**From:** Chris Grayson  
**Sent:** 8/12/2023 2:18:24 PM  
**To:** Council Northernbeaches Mailbox  
**Subject:** TRIMMED: Development Application DA2023/0617 – Objection Submission to Council - Revised Plan 16NOV23  
**Attachments:** DA2023\_0617 Objection 2 Letter v08122023.pdf;

## Development Application DA2023/0617 – Submission to Council

We, Chris Grayson and Claire Simon, residents of 2/72A West St, are writing to formally object to development application 'DA2023/0617' lodged with the Northern Beaches Council on 24 May 2023, with revised plans lodged on 16 November 2023. Despite the applicant having been provided with the 'Design and Sustainability Advisory Panel Report - DA2023061' (DSA Report) recommendations, the revised proposal still includes numerous areas of non-compliance with the report, as well as Manly LEP 2013 and Manly DCP 2013 standards.

Figure 1: Plans - Master Set 'Level 1 Floor Plan' pg4

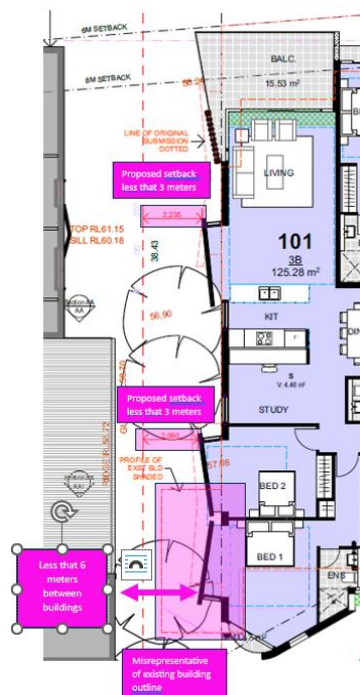
The proposed development lacks compliance with the minimum required (Manly DCP 2013) setback and DSA Report Recommendation 2 '*Comply with SEPP 65 ADG side and rear setback controls to maintain development potential equity for adjoining sites*' of 3.0-meters on the western boundary. As demonstrated below the revised Master Set Plans do not comply with 3.0 meter setback from the boundary and 6.0-meter setback between buildings. In addition, the existing structure where highlighted below is a ground floor carport which does not extend to a Level 1 height, a misrepresentation within the revised Master Set Plans.

Figure 2: Garbage Room inappropriate location and close to 72A living areas.

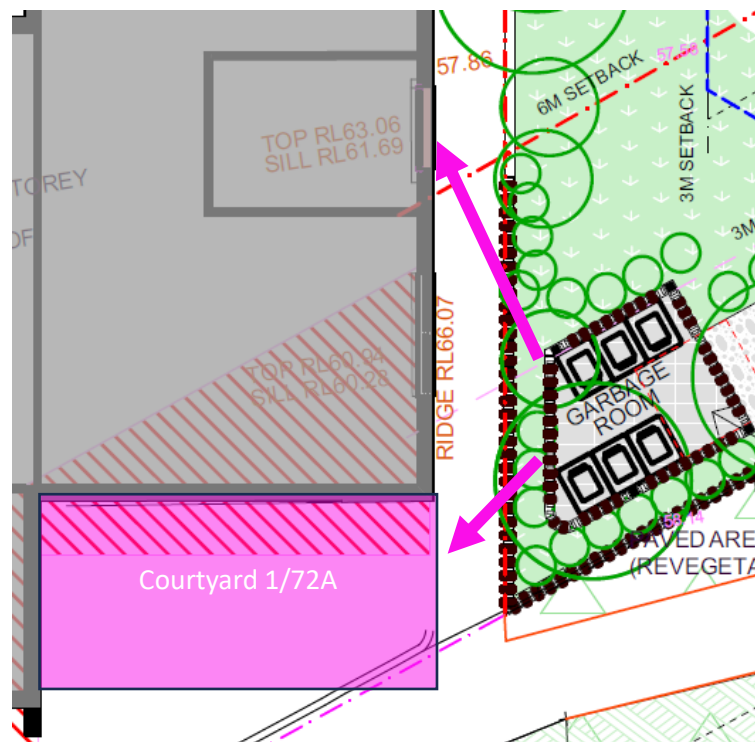
Furthermore, the revised location of the Garbage room results in a permanent structure setback less than 1m from boundary and less than 1.5m from the entrance to 2/72A and living and outdoor courtyard locations for 72A, as a result there would be daily and close occupancy to the proposed Garbage room. Nor is there an adequate location for bins to be set out for collection along south-west side of site (on Sydney Rd).

Figure 3: Sightlines between Level 1 Unit 101 Bedroom and 2/72A Living Room

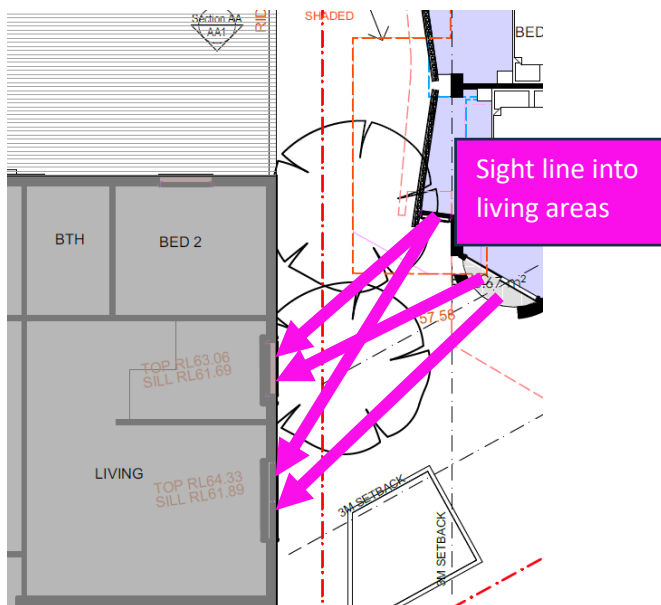
The proposed windows and balcony on Level 1 for Unit 101 (Bedroom 1) have direct sightlines into our (2/72A West St) living space raising concerns of both our privacy, but also the privacy of prospective occupants of Unit 101. In addition, Unit 101 slight lines from window and balcony would have an elevated sightline into 1/72A West St Bedroom 2 and Living area.

Figure 6: Plans - Master Set 'Ground Floor Plan' pg3

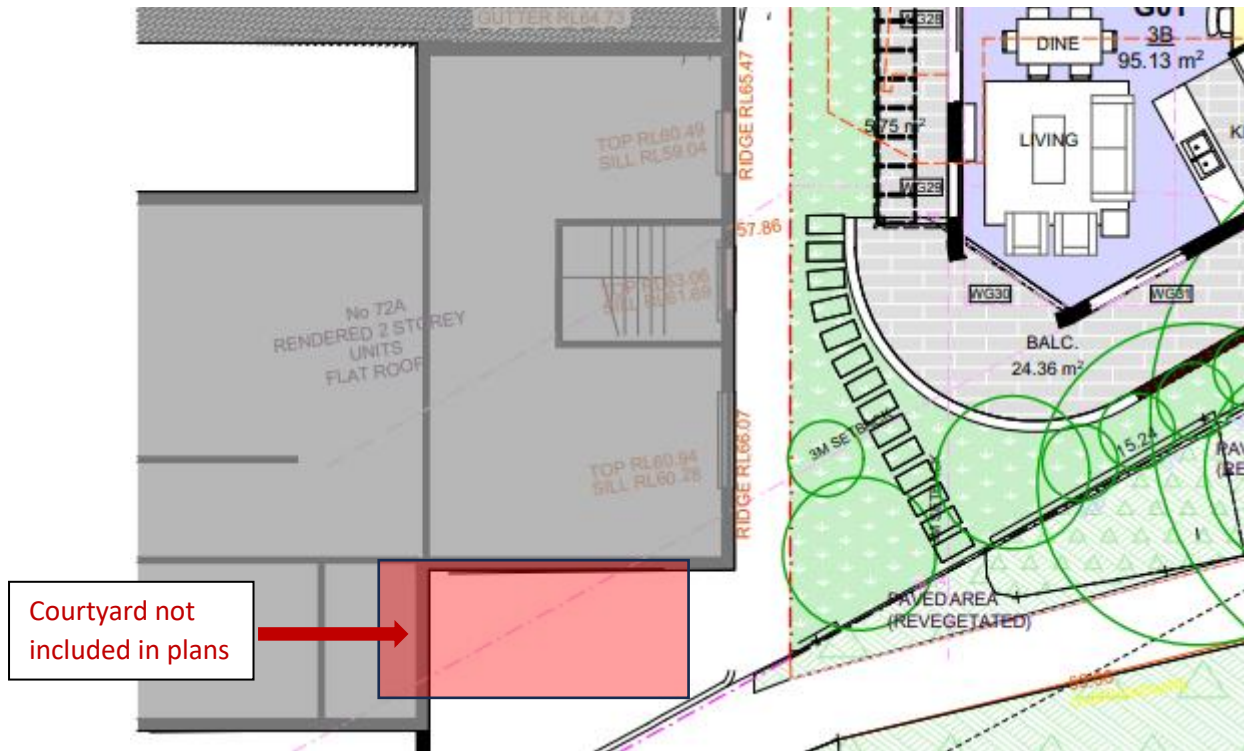
- Plans – Stormwater, pg3 – That an unapproved drainage easement along the southern boundary of 72 West St be sufficient, considering that approval for proposed easement is not guaranteed to be approved.
- Plans – Revised Master Set, pg3 – The existing plans do not include a courtyard that exists for unit 1/72A West St (as demonstrated below). Therefore, appropriate considerations related to the area have not been included in the submission including Garbage Room location.
